# SERVICE BULLETIN

NO. 237

1950

## SEVEN PANELS, SEVEN STEPS MAKE DOOR REPAIRS EASY ON ALL 1939 THROUGH 1950 PASSENGER CARS

### MODIFYING INSTRUMENT BRACKET TO ACCOMMODATE NEW SPEEDOMETER - 2R SERIES

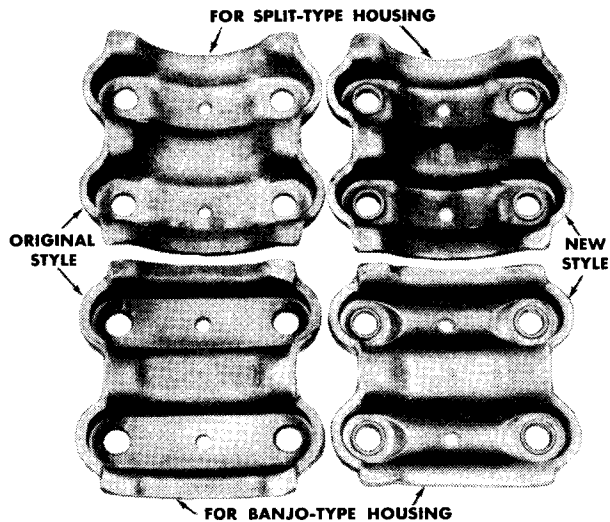
When installing the present type speedometer assembly (with an oiler on the rear) in trucks equipped with Part No. 652463 original bracket, it will be necessary to enlarge the hole in the bracket from the dotted line X to the solid line B as shown in the accompanying illustration.

The illustration is full scale, so that a template can be traced from it and placed on the bracket. The dotted lines indicate the size of the holes in the original Part No. 652463 bracket.

If, for some reason, the new type bracket, Part No. 653082, is used to hold the original speedometer in place, it will be necessary to file out the half-hole shown by the dotted line at A.
